Fire Protection Evaluation
Building 304 - Maintenance Hangar

Tulsa International Airport

11 March 2016

FS-16 **Hangar Bay Wet-Pipe Sprinkler System**

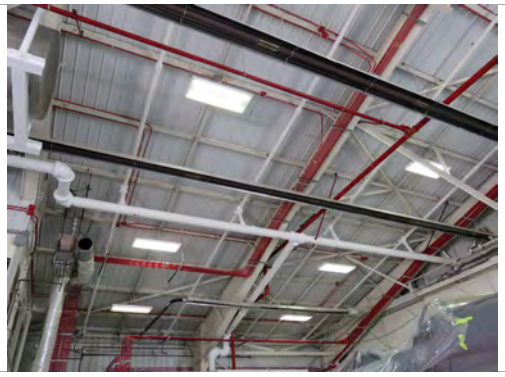
- Automatic air vents are not provided at the high point(s) of the wet-pipe sprinkler system. UFC 4-211-01 para 3-5.8
- 99.6% dry bulb temperature is less than 32 degrees F per UFC 3-400-02 Engineering Weather Data, and an inspectors test connection is located in the hangar bay. UFC 4-211-01 para 3-5.8

- A valve which when opened may discharge the foam/water system (inspector test connection, system drain valve) is not locked closed. UFC 4-211-01 para 3-5.11.14

- Sprinkler pattern development for the sprinklers appears to be obstructed. The insulation on the sprinkler branchline piping is greater than 3 inches in diameter and therefore the sprinklers are partially obstructed by the insulation. A pre-action system is not required in this area per UFC 4-211-0-1 para 3-5.8, however, it is an option to remove the obstructions to the sprinklers caused by the insulation. NFPA 13 para 8.6.5.2.1.8.

- Heat tracing does not appear to be U.L. listed for use on fire protection systems. NFPA 13, A.7.6
- Piping is not adequately labeled (e.g. Hangar bay sprinkler system). UFC 4-211-01 para 3-5.5.2

- Undetermined if waterflow switch delay or retard chamber is equivalent to 60 seconds or greater. UFC 4-211-01 para 3.5.11.12

Item	QTY		Rate	
Pre-action Sprinkler System	9300	SF	Per SF	
Pipe Labels, Labor and Materials	8	Hrs	Per Hr	
Lock for Valve	1	Items	Per Item	
Automatic air vent	6	Items	Per Item	
Inspectors Test at Wet Riser	1	Items	Per Item	
Remove Wet Sprinkler System	9300	SF	Per SF	
Remove Insulation and Heat Trace	9300	SF	Per SF	
			Total:
